City of Bellevue
Department of Planning and Community Development
Development Services Division Staff Report

Proposal Name: Chao Preliminary Short Plat
Proposal Address: 4431 130th Avenue SE
Proposal Description: To subdivide 22,484 square feet into 3 single-family lots.
File Number: LN-06-124810
Applicant: Victor Chao
Decisions Included: Preliminary Short Plat Decision (Process II)
Planner: Antoinette Pratt, Senior Planner

Department Decision: Approval with Conditions

PROPOSED SHORT PLAT

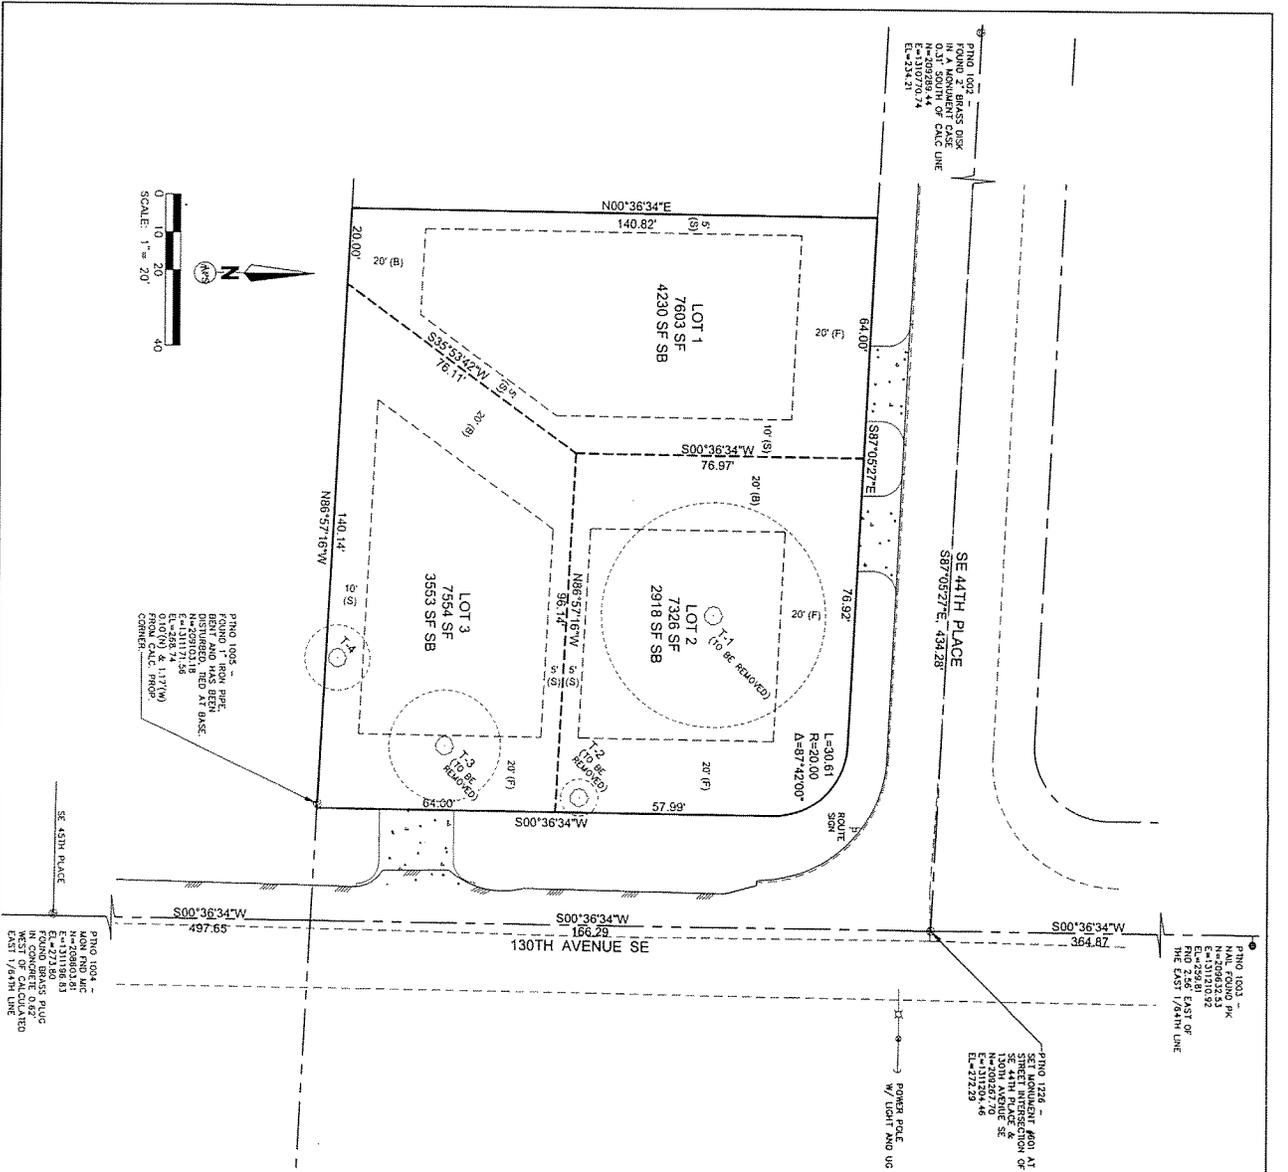
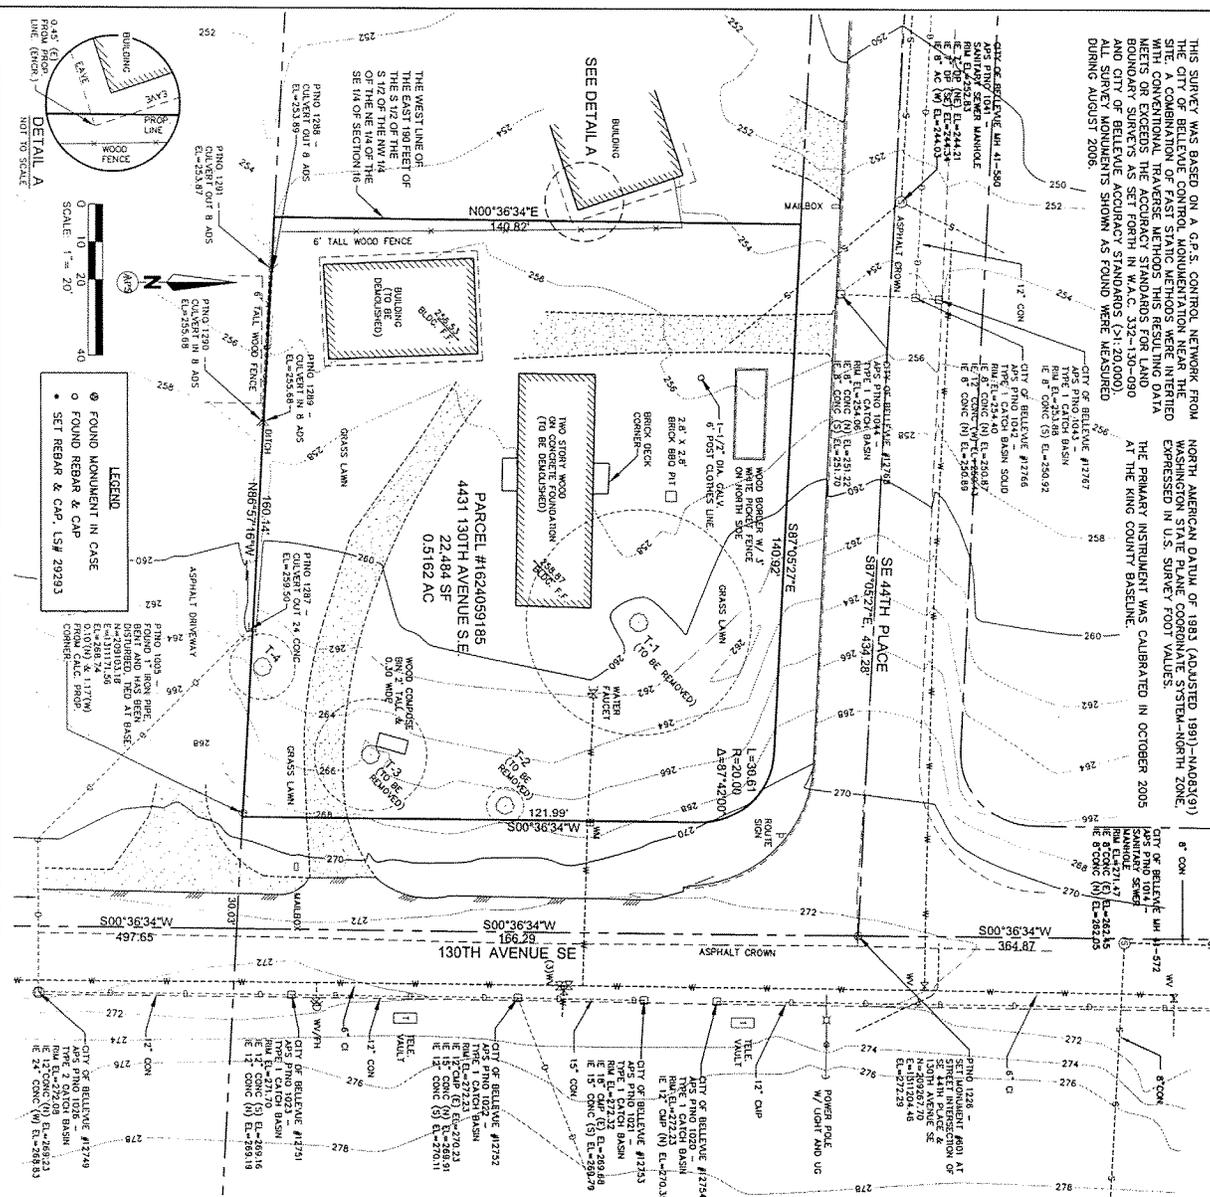
2. The provisions of LUC Section 20.20.900.D.2.a requires the applicant to save 15 percent of the total diameter inches of significant trees (8-inches or larger) on-site. There are four existing significant trees on this site. The applicant has proposed to retain one of four of the existing trees which is located along the south property line on lot 3. The applicant will need to protect this tree by establishing a Tract around tree #T-4 which is along the south property line. As a condition of approval, the applicant will be required to establish a tract for tree retention for tree designated #T-4. See Section VII for related condition.

The applicant has fulfilled the 15 percent by designating 55 diameter inches for tree retention which is over the 15 percent threshold of 20 diameter inches. Additionally tree protection language has already been added to sheet 1 of 1 to protect this tree in perpetuity.

The applicant shall establish a tree protection area around tree #T-4 which is along the south property line. This tract shall be established prior to final short plat approval.
